### MILWAUKIE PLANNING COMMISSION Tuesday, February 14, 2017, 6:30 PM

- 5.1 Summary: Harmony Rd Mini-storage  
Applicant/Owner: Hans Thygeson  
Address: 5945 & 5965 SE Harmony Rd  
File: CU-2016-001, NR-2016-001, TFR-2016-001, VR-2016-003  
Staff: Brett Kelter

Figure 4. Proposed site plan

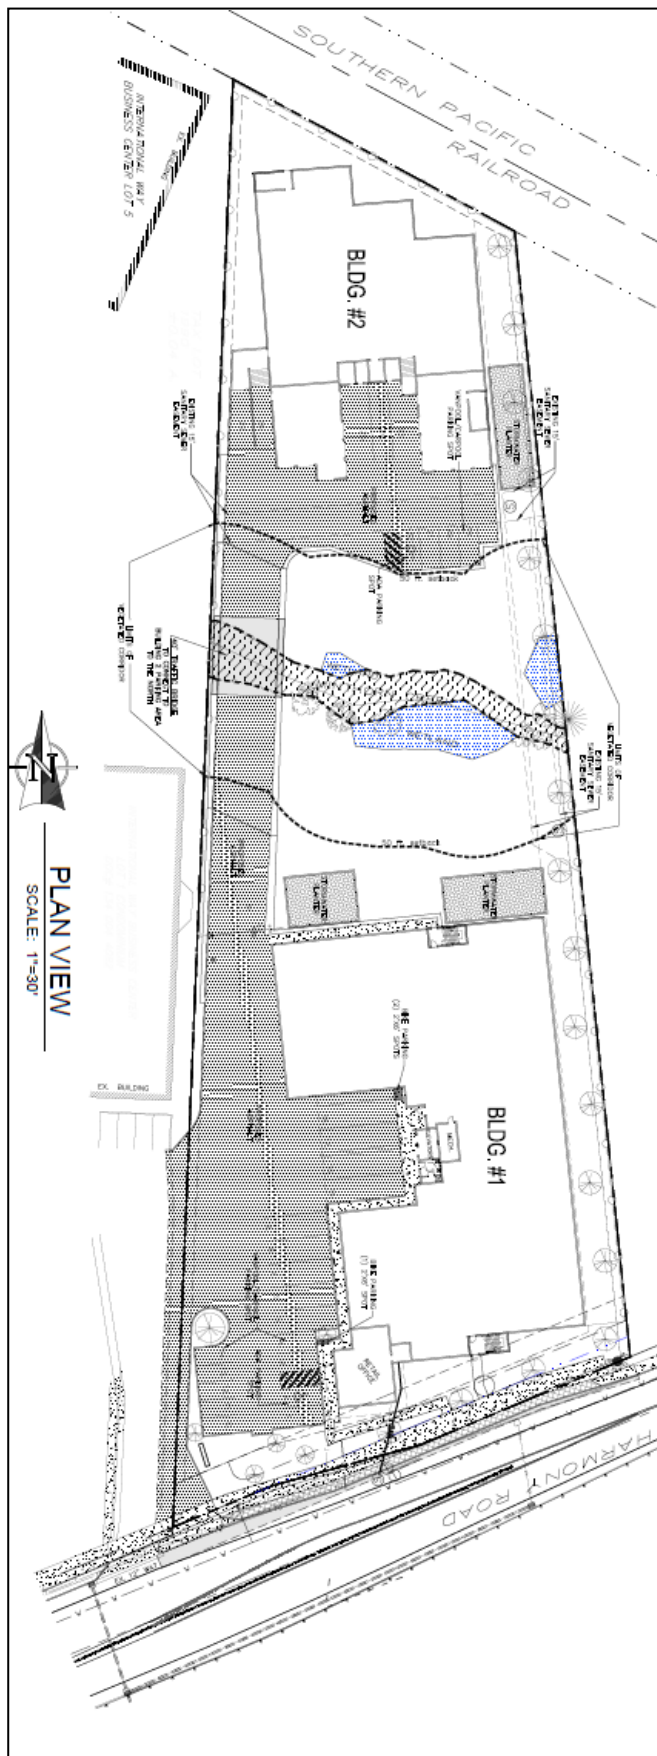
The applicant is seeking land use approval for development of a commercial mini-storage facility on the subject property, with 1,005 enclosed units in two 3-story buildings (see Figure 4). Mini-storage is a conditional use in the underlying Business Industrial (B-I) zone.

**Figure 6.** Perimeter landscaping at southwestern parking area—less than 2 ft wide adjacent to stall 14 and less than 6 ft wide adjacent to other several other stalls

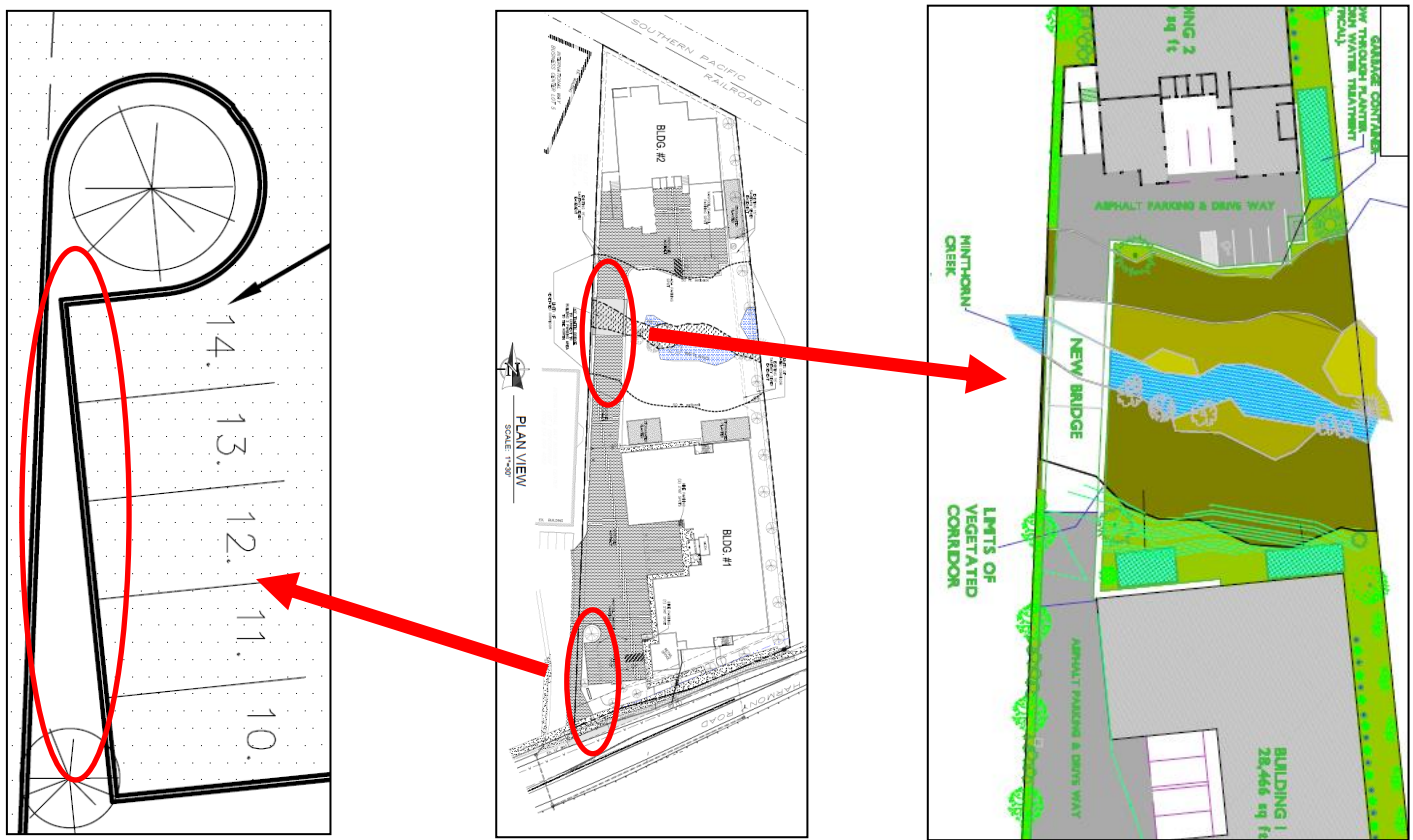
As proposed, the perimeter landscaping adjacent to the southwestern parking area does not meet the minimum width requirement of 6 ft where it abuts the accessway to Harmony Road. The angular, non-rectilinear shape of the subject property results in a portion of the southwestern parking area being less than 2 ft wide—in addition, the narrow strips adjacent to the new accessway leading to and across the proposed new bridge and on the western end of the northern parking area are also less than 6 ft wide (see Figure 6).

MMC 19.402.15 establishes standards for verifying the boundaries of WQRs and HCAs and for administering the City's Natural Resource (NR) Administrative Map.

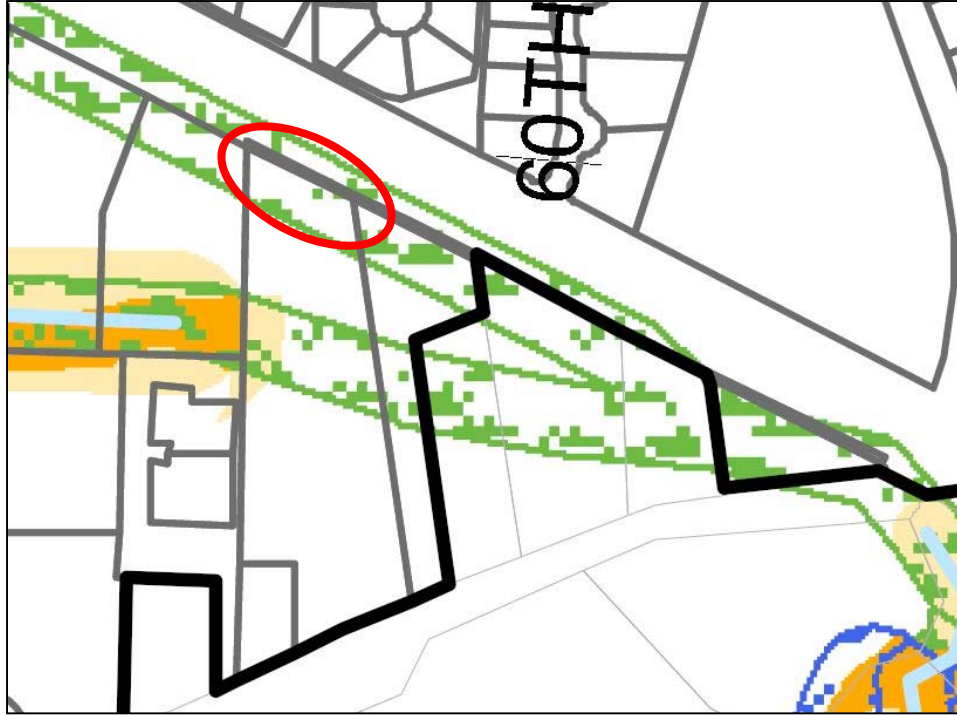
- **WQR and HCA boundaries:** The boundaries of Minthorn Creek, wetlands, and the 50-foot setbacks appear accurate. As indicated on Figure 4 of the narrative, no slopes exceed 25% when measured in 25 foot increments from the OHWM/wetland boundaries. The boundary of the HCA also appears accurate according to the City's map. As a separate housekeeping note, the WQR mapping at the north end of the property appears to be outdated. See Exhibit A below.

Exhibit B: Erosion control plan – we recommend extending silt fencing along entire length of WQR.

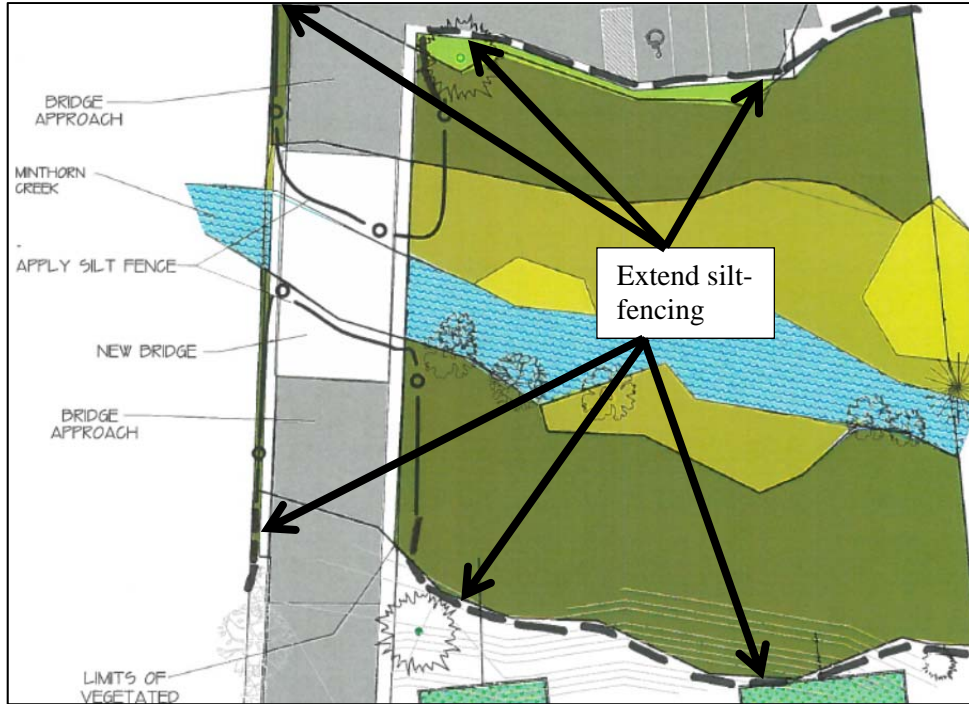
- Figures 5 and 6 of the narrative show landscape trees in a strip through the WQR along the eastern property line. Please describe what this involves (i.e. clearing of understory, etc.) and the purpose. Describe the impacts to the WQR and mitigation.
- Proposed planting list: We understand that the plant quantities shown on Figure 6 are correct and that Table 4 on page 9 of the narrative shows the incorrect quantities. Please update Table 4.
- Grading plan: Show limits of grading on the ECP to be consistent with Grading Plan.
- Erosion control plan: The ECP provided shows silt fencing stopping short of the WQR limits. We recommend extending the fencing up the slopes and around the water quality buffers to improve the function of silt fencing (see Exhibit B below).

Exhibit C: Measures to reduce bridge scour.

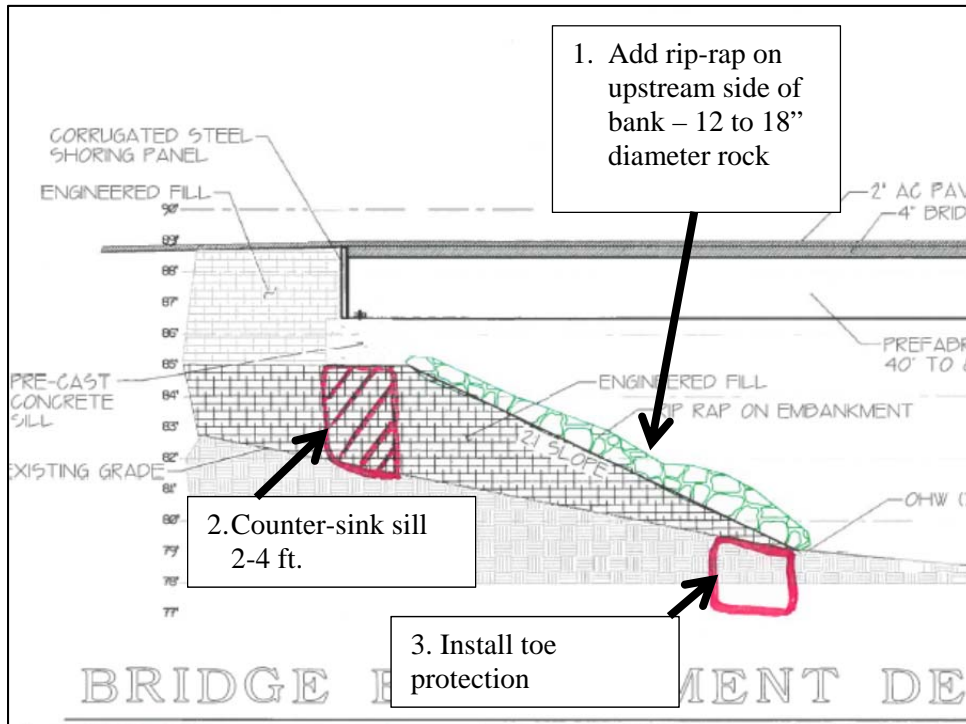
- Bridge design: We understand Minthorn Creek is a small stream with low flow; however, consider the following measures in Exhibit C to reduce the risk of scour during large storm events for the lifespan of the bridge:

Exhibit D: Address the existing bridge to the west as a project alternative.

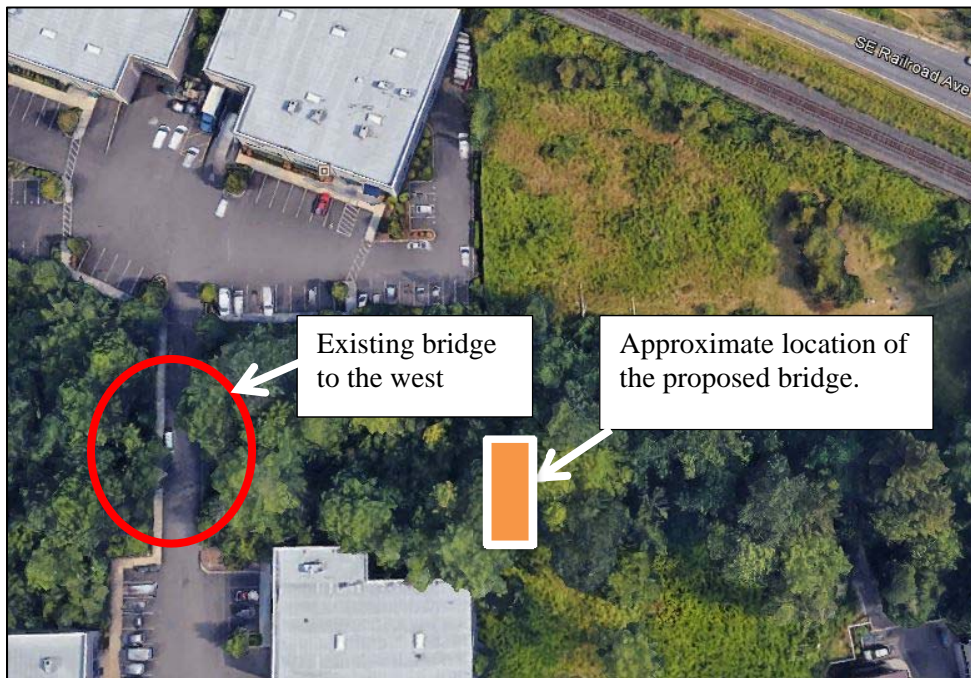
- The orientation of Minthorn Creek and the presence of the railroad clearly limit access to the north side of the property and the narrative states that there are no practicable alternatives other than a proposed bridge for developing the northern portion of the site. As part of a complete review of avoidance options, the narrative could briefly address whether the bridge on the neighboring property to the west was considered as an alternative and why it is or isn't practicable (see Exhibit D below).
